City of Keene Planning Board

AGENDA

- V. **Public Hearing**
 - a. **PB-2024-18 – Cottage Court Conditional Use Permit – 133 Roxbury St** - Applicant Unicron Management, on behalf of owner Mahantrashti Real Estate LLC, proposes the conversion of an illegal 7-unit building at 133 Roxbury St (TMP #569-099-000) into four units. The parcel is 0.25-ac in size and is located in the High Density District.

Figure 2. A snippet of the proposed conditions plan for 133 Roxbury St.

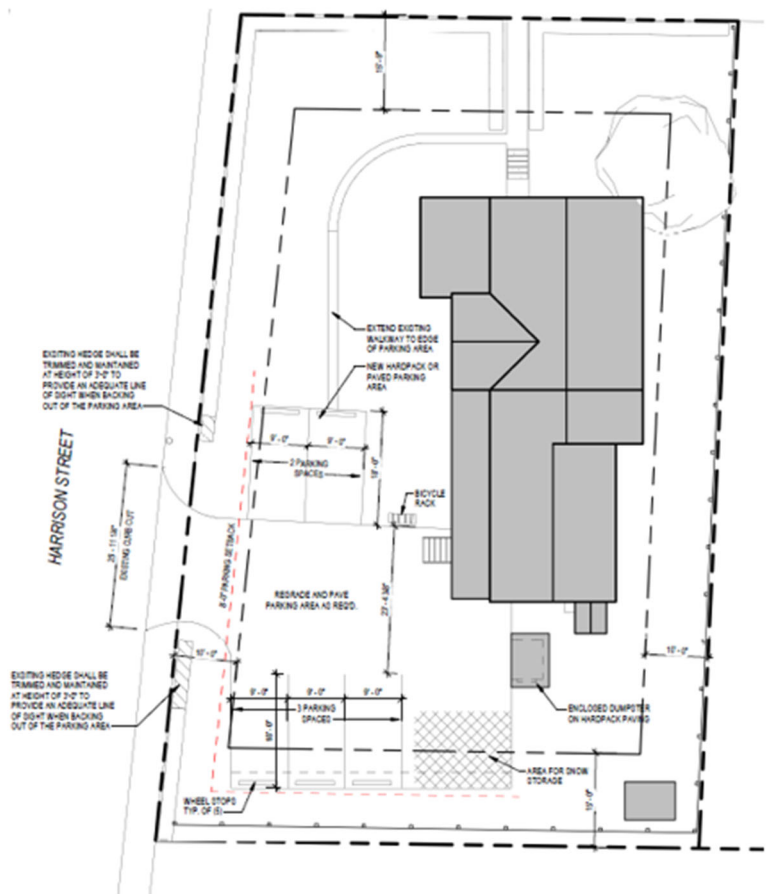
- The existing driveway is in poor condition and has a ponding low point area adjacent to the City’s existing sidewalk; it is recommended that the driveway at the interface with the City’s sidewalk be reclaimed, re-graded and repaved to provide positive pitch to eliminate the ponding adjacent to the City’s sidewalk and road infrastructure.
- The width of the existing driveway with parking on either side appears insufficiently wide for cars to turn around in the driveway and requires them to back out into the road. Given this, the existing bushes along the property frontage on both Harrison Street and Roxbury Street are recommended to be cut back to minimize the current line of sight obstructions and eliminate the obstruction of the City’s sidewalk.

Article 21.2 - Drainage & Stormwater Management: City Engineering Staff noted that the existing driveway is in poor condition and has a ponding low point area adjacent to the City sidewalk. The City Engineer recommends that this portion of the parking area be regraded and repaved to fix these issues and improve safety. The Plans Examiner / Floodplain Manager noted that the entire southwestern portion of the parcel is located within the floodway as shown in Figure 3. In accordance with Section 24.3.1 of the Land Development Code (LDC), this work may require the submittal of a Floodplain Development Permit application, unless there will be no decrease in the existing flood storage area on the site as a result of the grading changes.

In response to the City Engineer's comments, the applicant stated that the existing parking area would be regraded and repaved to provide a positive pitch to eliminate ponding adjacent to the City's sidewalk and road infrastructure. An updated proposed conditions plan with a note stating that the parking area would be repaved and regraded was submitted as part of the revised application materials.
